1964 Corvette: Engineering Service Letter: Increased Capacity Fuel Pump

Subject: Increased Capacity Fuel Pump

Model and Year: 1964 Corvette 365 - 375 HP Engine And/Or Air Conditioning

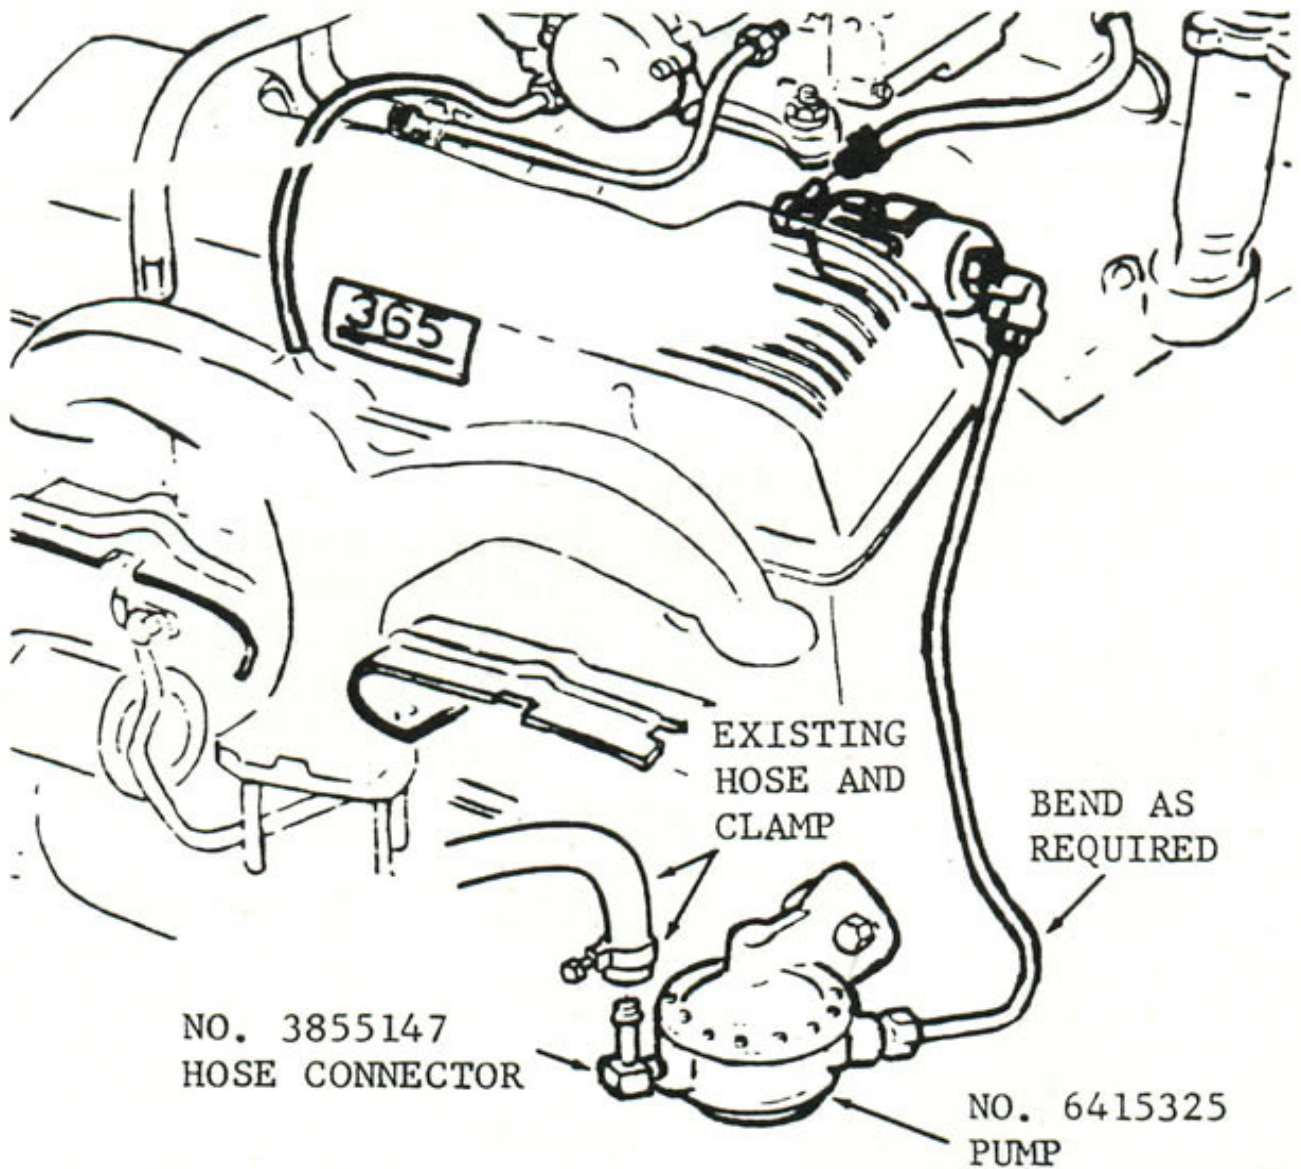
Corvettes with high performance engine options and/or air conditioning may experience a fuel vapor lock condition during high ambient temperatures. To eliminate this possibility, a new high capacity fuel pump is used on late production units with the subject options. The new high capacity pump includes vapor bleed holes in the inlet and outlet valves.

To install the new design pump on early production Corvettes, replace the existing pump with part number 6415325 Pump and part number 3855147 hose connector elbow. Bend the existing gas line as required to match the outlet fitting.
